TOWN OF CARRBORO

SUBJECT: JOINT REVIEW FOR THE 610 HOMESTEAD ROAD ARCHITECTURALLY INTEGRATED SUBDIVISION SPECIAL USE PERMIT.

STAFF REPORT

PROJECT: 610 Homestead Rd Architecturally Integrated Subdivision
Special Use Permit

SUP - SITE PLAN

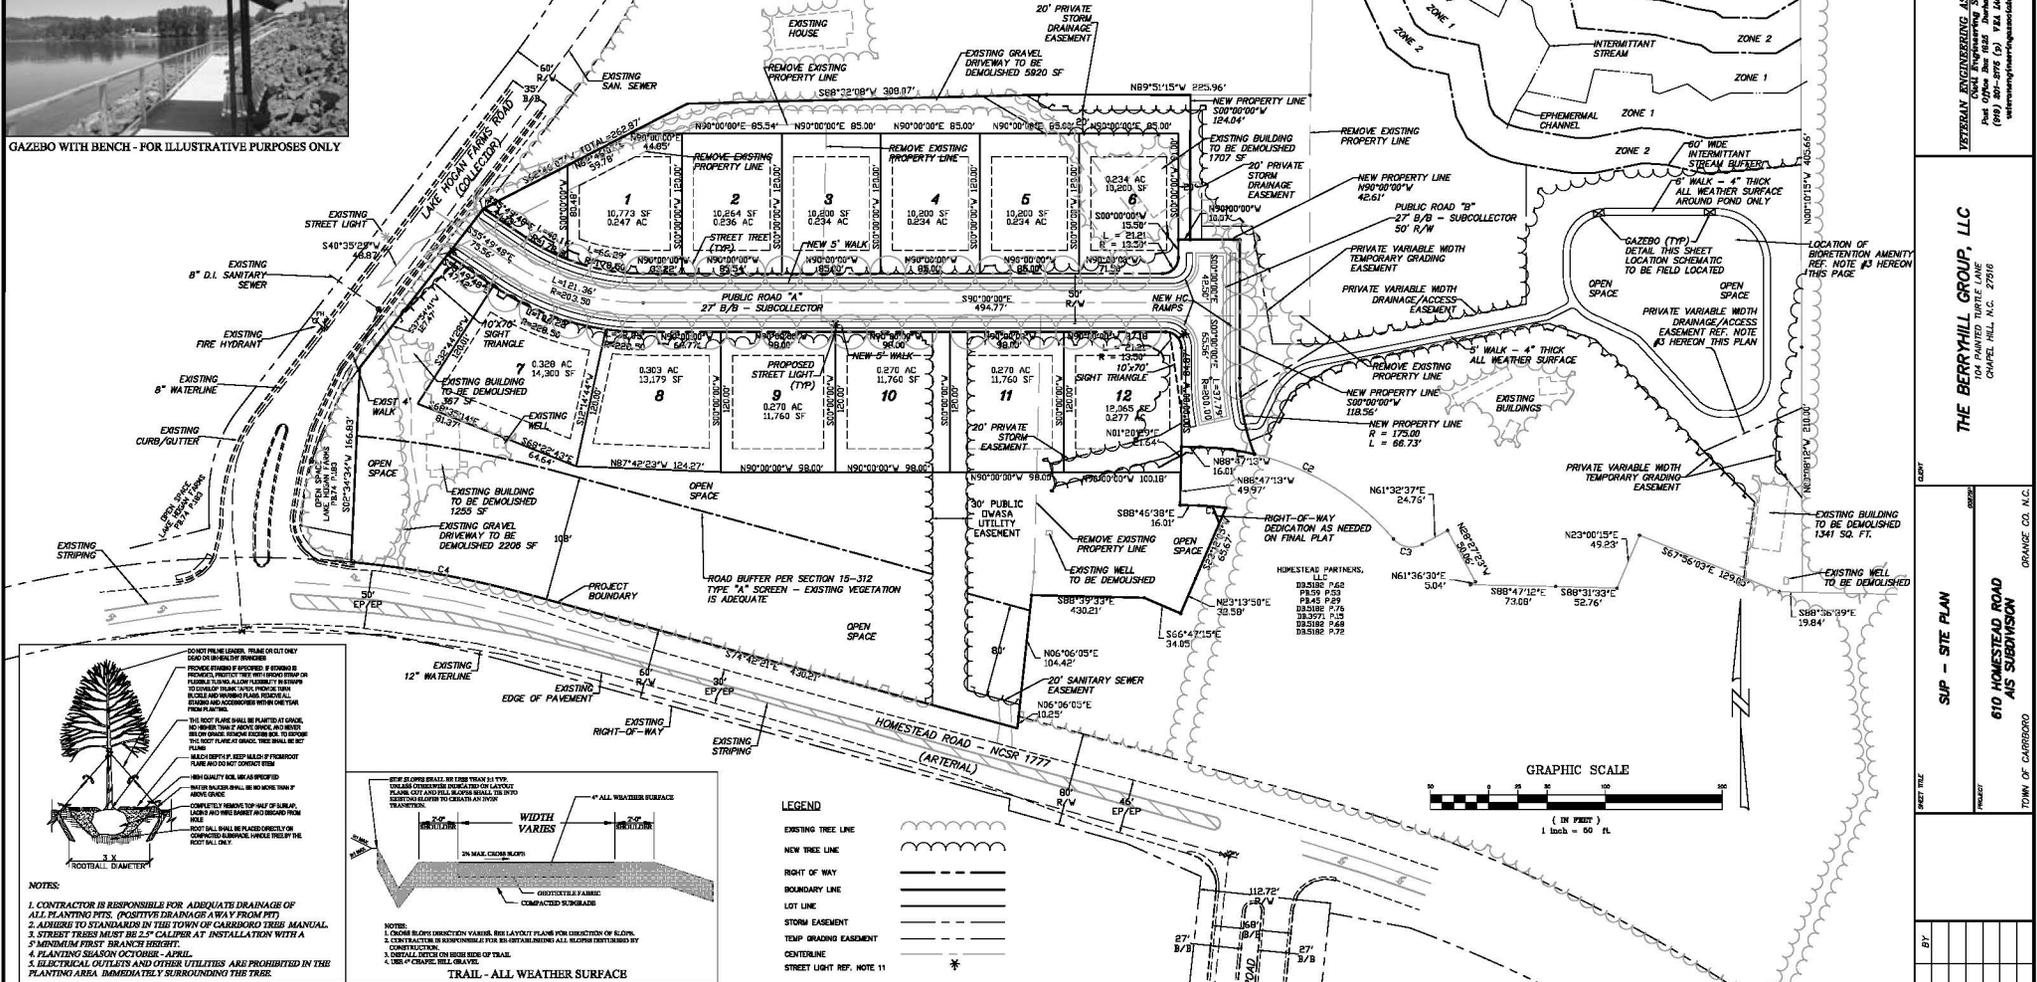
In order to satisfy the 40% requirement, the applicant is therefore claiming the area associated with the off-site BMP as illustrated in the exhibit on SP-1 of the attached project plans (Attachment B). In order for this facility to counted toward open space it must be improved in such a way as to be "conducive to actual use for passive recreation purposes by residents of the development where located" (15-198); to this end the applicant has provided the walking trail and gazebo rest-stations around the BMP and has taken steps to design the facility to be an attractive natural feature (Attachment H).
